STAFF REPORT: 12/11/2024 MEETING

ADDRESS: 2044 CHICAGO

APPLICATION NO: HDC2024-00265

SCOPE: REPLACE WINDOWS

Photo taken in early 2018, prior to the fire. Note that all windows at the front are wood casement windows with leaded glass. The windows at the second story are covered by aluminum windows. Source, HDC files

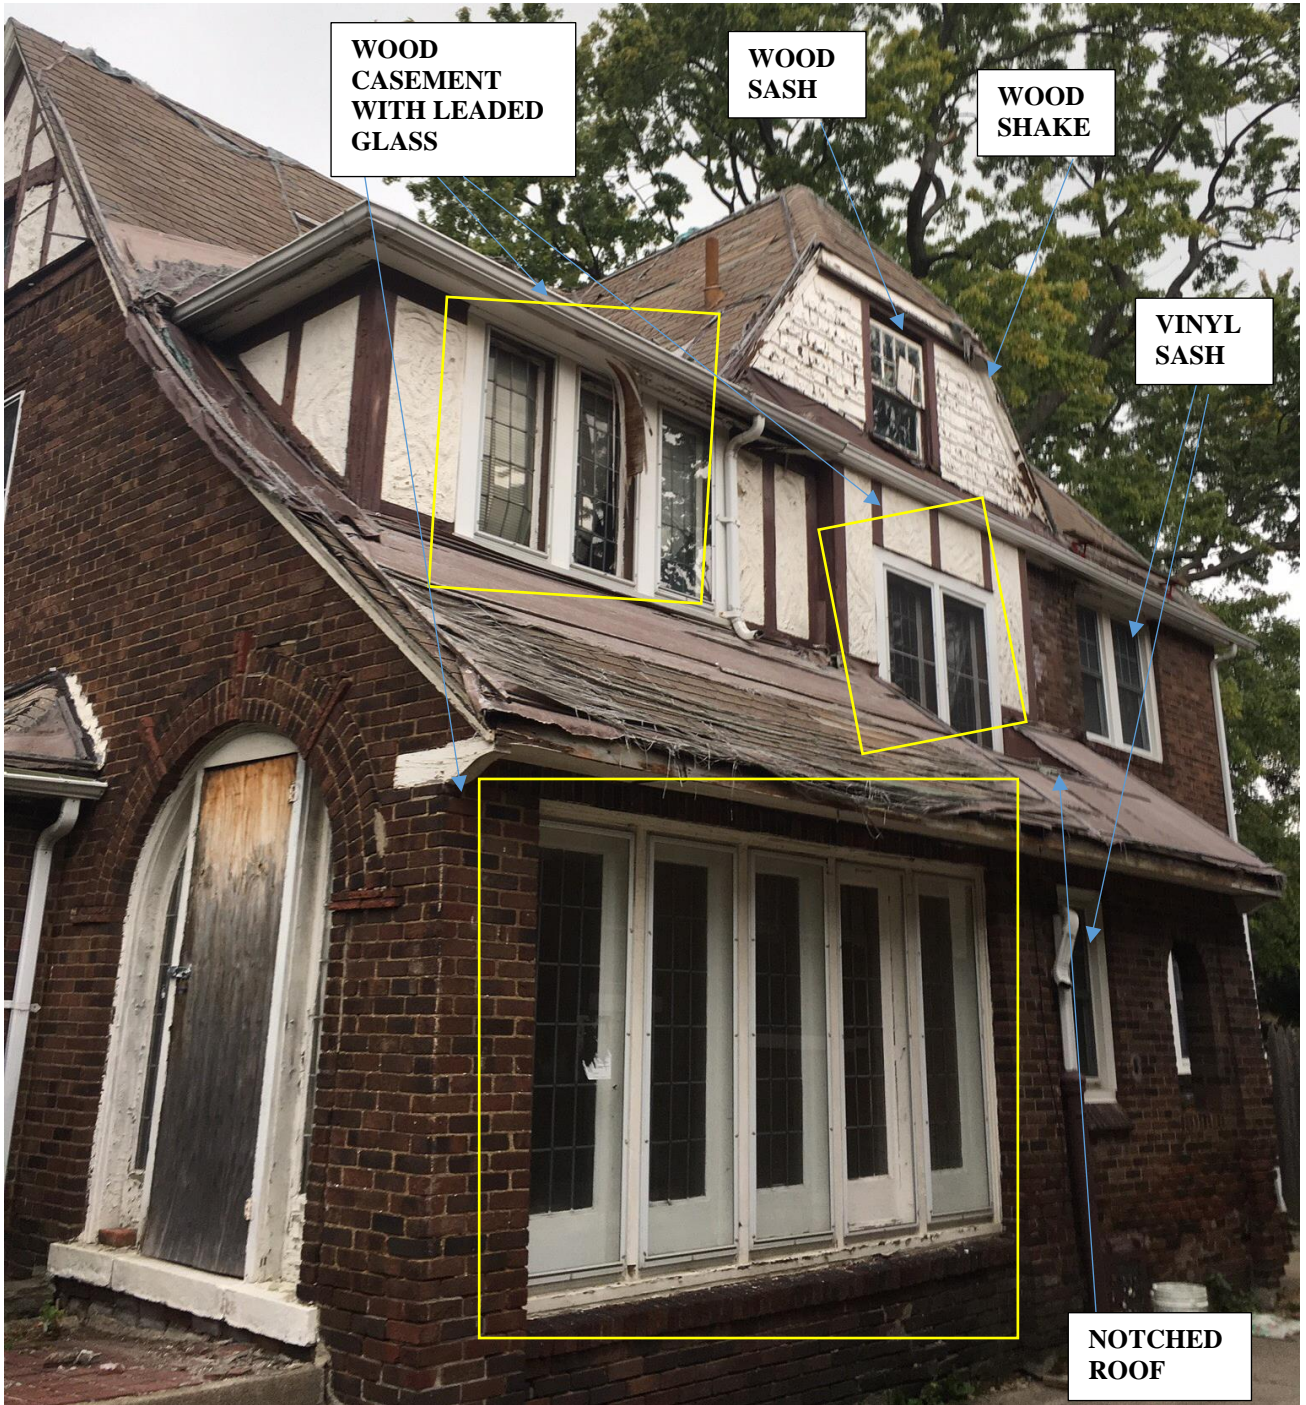
ARCHED
OPENING

LEADED GLASS
CASEMENT
WINDOWS AT
FRONT FACADE

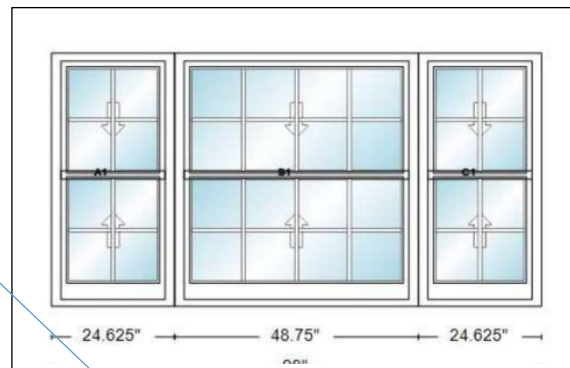
- One, double-hung, 8/1 wood window in the east elevation attic story dormer (below left photo). The proposed window is composite and wood, fixed six pane, simulated divided lite window (below right photo).

It is staff's opinion that the proposed new window is incompatible because a fixed window of this size is not commonly found at this location on a house of this vintage.

- The fixed, composite and wood, six pane, simulated divided lite window proposed for installation at the east elevation attic story dormer to replace a casement window that was destroyed by the fire is not compatible with the property's historic character as large fixed casement window would not be commonly found at this location on house of this style and vintage.
